Item 4.**Development Application: 163 Bridge Road, Glebe - D/2022/285**

File No.: D/2022/285

Date of Submission:	28 April 2022 Amended plans - 26 August 2022 and 7 October 2022
Applicant:	Mr Jonathon Wood
Architect/Designer:	Nimbus Architecture + Heritage
Owner:	The Trustees of the Roman Catholic Church for the Archdiocese of Sydney
Planning Consultant:	Think Planners Pty Ltd
Heritage Consultant:	Nimbus Architecture + Heritage
Cost of Works:	\$1,823,682.72
Zoning:	The site is located within the R1 - General Residential zone. The use is defined as a function hall ancillary to a place of public worship, and co-living, and is permissible with consent within the zone.
Proposal Summary:	<p>Approval is sought for alterations and additions to an existing parish building, comprising refurbishment of the existing parish hall at ground floor and continued use for community facilities, change of use of level 1 and construction of an additional storey at level 2 for 13 co-living rooms in total, with 14 bicycle and three motorbike spaces, and associated landscaping works.</p> <p>The application is being reported to the Local Planning Panel for determination as the development exceeds the heig

Figure 28: Long section showing the 9m height control dashed

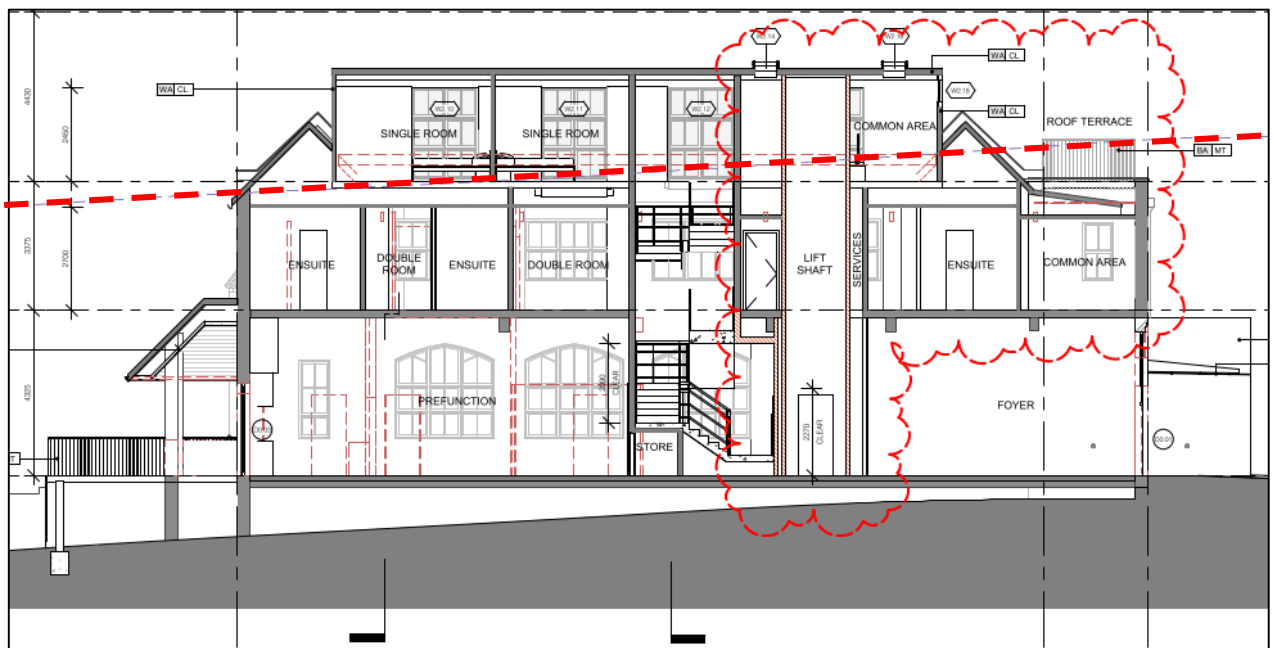
- 42. The site is subject to a maximum height control of 9m.
- 43. The proposed development includes additions to the roof of the building with side dormer windows and roof extensions that exceed the height control, creating a third storey, with a maximum height of 12.4m above existing ground level, resulting in a variation of 3.4m or 37.7 per cent from the development standard. The additions are below the ridge line of the existing roof.

48. The applicant has demonstrated that there are sufficient environmental planning grounds for justifying the standard in that the extent of the proposed dormers and roof additions are recessive and sympathetic to the heritage qualities of the existing building, do not increase the overall height of the existing building and do not result in any unreasonable amenity impacts to neighbouring properties or adverse heritage impacts to the existing parish building.

Figure 29: Ground floor plan showing communal open space area

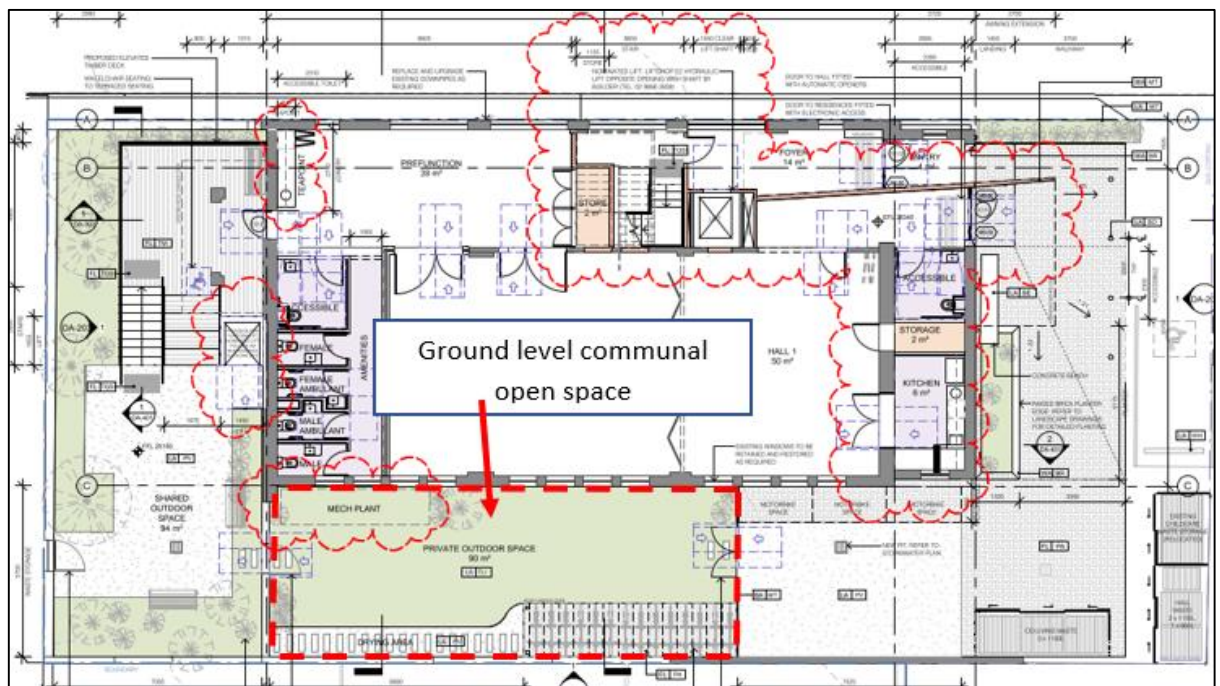
51. The development is required to provide a total area of 20 per cent of the site (144 sqm) based on a site area of 720sqm, with a minimum dimension of 3m under Cl 68 (2)(d) of the State Environmental Planning Policy (Housing) 2021. The proposal provides 90 sqm of communal open space on the southern side of the building, and 26 sqm communal roof terrace, for a total of 116 sqm (or 16 per cent) of communal open space, which is a shortfall of 19.4 per cent.

56. The applicant has demonstrated that there are sufficient environmental planning grounds for justifying the standard. Although non-compliant with the communal open space development standard, the proposal provides communal living areas in excess of the requirements of the SEPP (Housing) 2021 (by 13 sqm), which is considered to offset the deficiency in communal outdoor space.

Figure 30: Second floor plan showing communal open space area

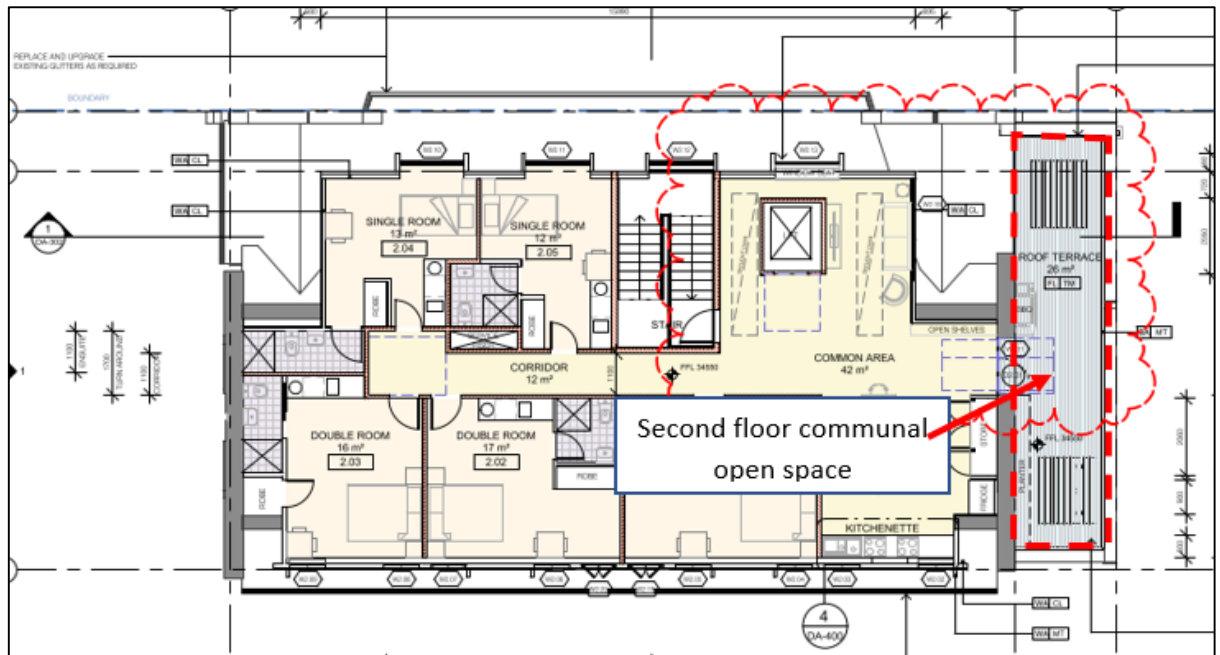
76. The roof terrace on level 2 serves as a secondary common outdoor area, as it is directly accessed from the level 2 communal indoor area, and will receive improved solar access, as it is east facing. In addition, the revised scheme has included seating and a BBQ area in the roof terrace.

Figure 31: View from Woolley Street looking north

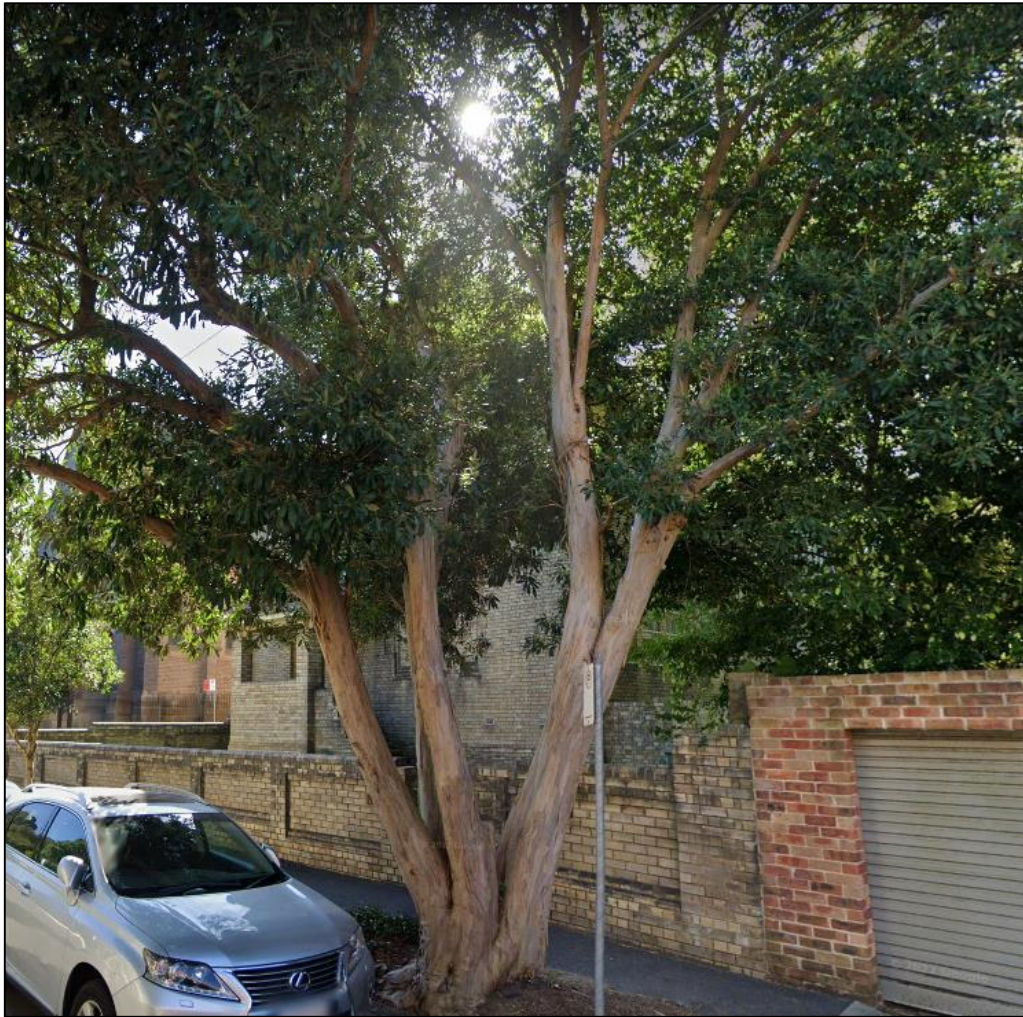
63. Only the side of the roof additions and dormer windows on the southern elevation will be visible from Woolley Street looking east towards the subject site. Views from further south along Woolley Street looking north will be obstructed by the canopy of the existing street tree, as well as mature trees within the rear yards of the southern neighbouring terraces, as demonstrated in the below images.

Figure 40: location of the ground level outdoor communal area shown dashed

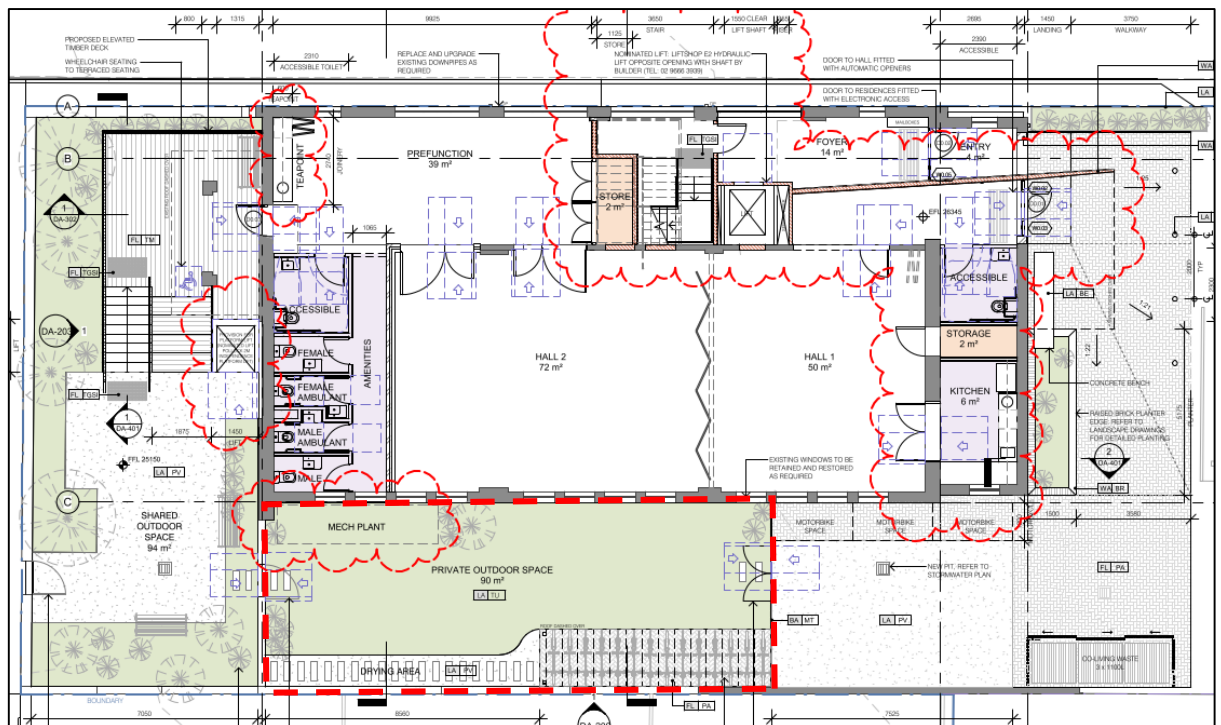
75. Although, the amenity of the ground level communal open space is limited by its location on the south side of the building, it is acknowledged that given the constraints of the site and existing building, there is limited opportunity for an alternate location. The area to the east of the building is occupied by an existing outdoor carpark serving both the parish hall, and the child care centre. The outdoor area to the west of the building is associated with the main entrance to the parish hall community centre, and is even further removed from the entrance to the co-living rooms, requiring residents to travel around the entire building.

Figure 41: location of the level 1 indoor communal living area shown dashed

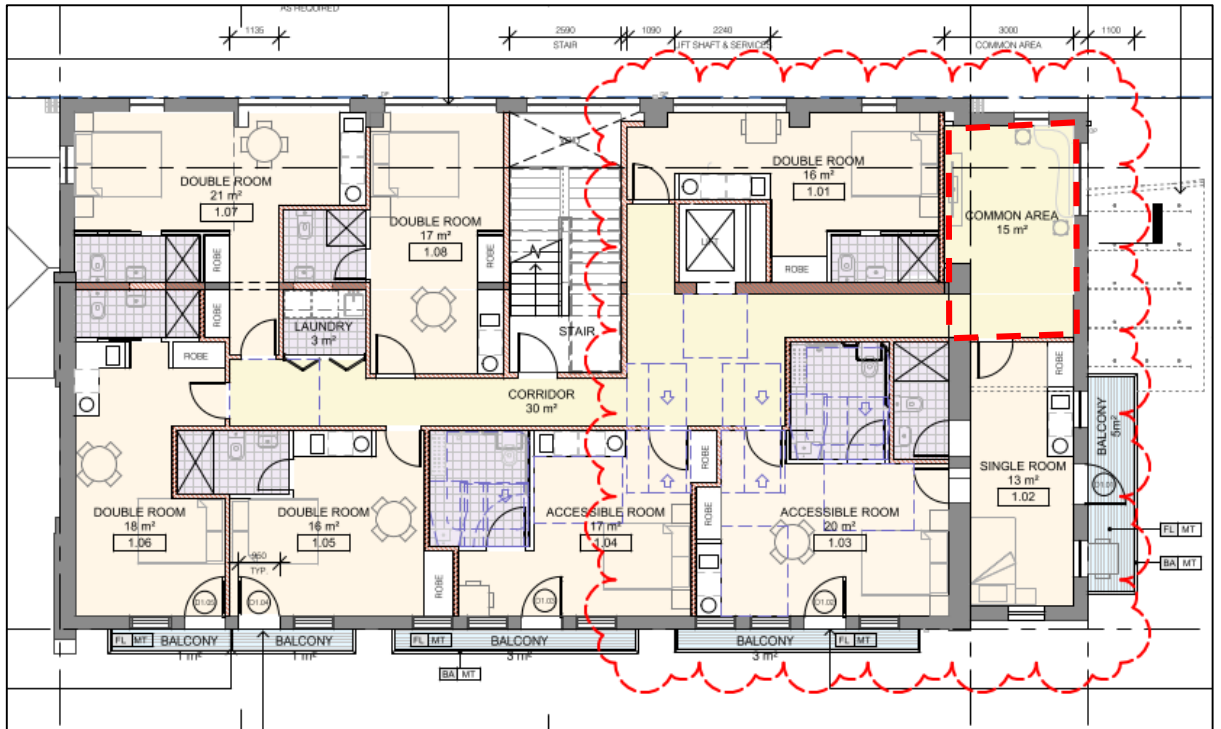
77. During the assessment, the applicant was advised that level 1 and 2 should be reconfigured to provide better amenity and useability to the communal indoor areas to compensate for the limited amenity to the primary common outdoor area. In response, the internal layout of level 1 was reconfigured to relocate the communal area to the north-east portion of the floor, creating 15sqm of usable area. The revised location of the level 1 common area is considered an improvement, as it will receive unobstructed natural light and ventilation.

Figure 42: location of the level 2 indoor communal living area and outdoor communal open area (roof terrace) shown dashed

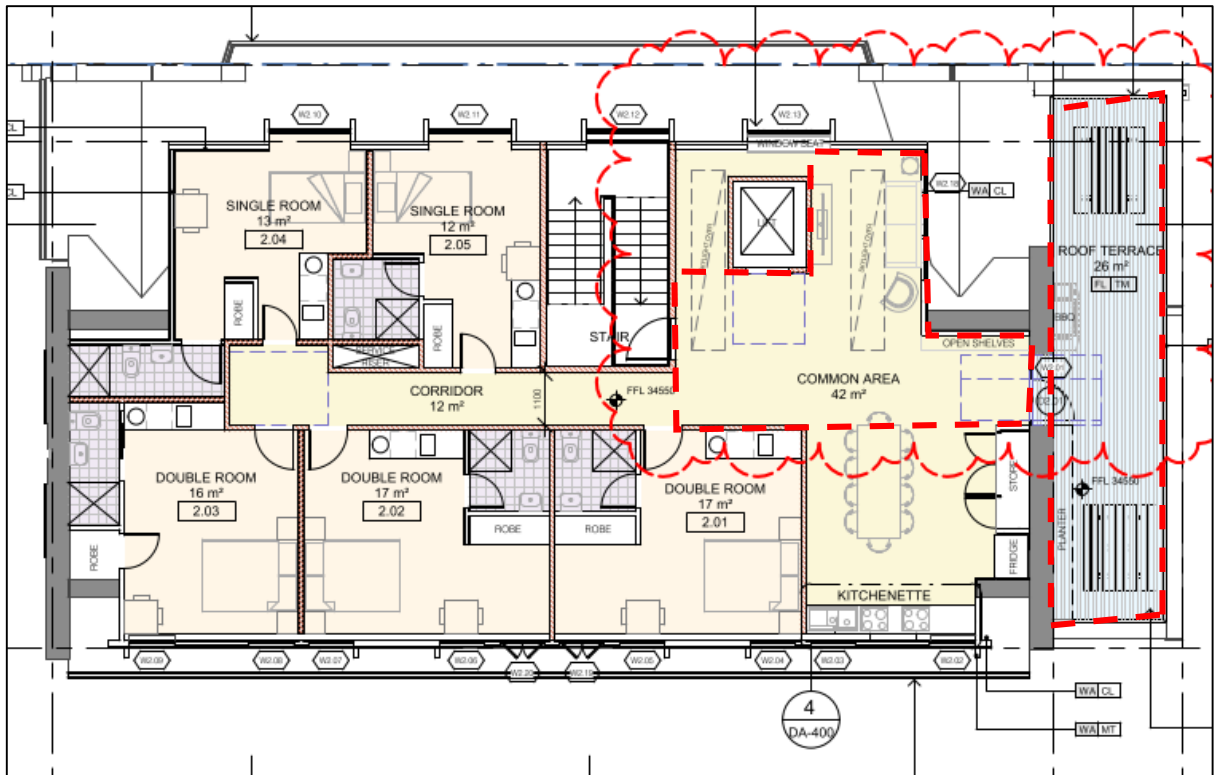
79. The design changes made in the revised scheme are considered to greatly improve the amenity and useability of the indoor common areas and roof terrace to adequately compensate for lesser amenity provided by the ground level common outdoor area, and are considered an ideal design outcome given the site constraints of the existing building. A condition is recommended for the ground level common outdoor area to incorporate two fixed benches with piered footings to provide seating for residents located away from the mechanical plant and drying area.
